Citizens Advisory Committee #2 – Feedback Worksheet

Feedback from Citizen Advisory Committee (CAC) members is compiled below.

Figure 1. Allen's Creekshed with elevation, streets, and floodplain

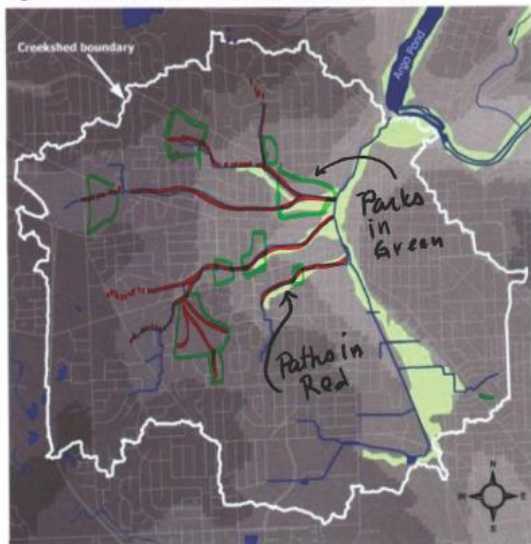
- As commented on before the **Allen's Creek ravines**, branches of the watershed to the west of the Greenway, should be considered potential feeders to the Greenway and downtown as off road routes for bikers and walkers. Great potential here similar to the main Greenway. The ravines are currently green open space generally and the one behind our house is used for walking and biking. Eberwhite woods and other west-side parks have many trails that could be connected to a ravines system.

Revines along Allen's Creek Tributaries: (images from ACWG.ORG Watershed Management Plan)
Potential paths to the main greenway shown in Red, many connect to existing park paths.
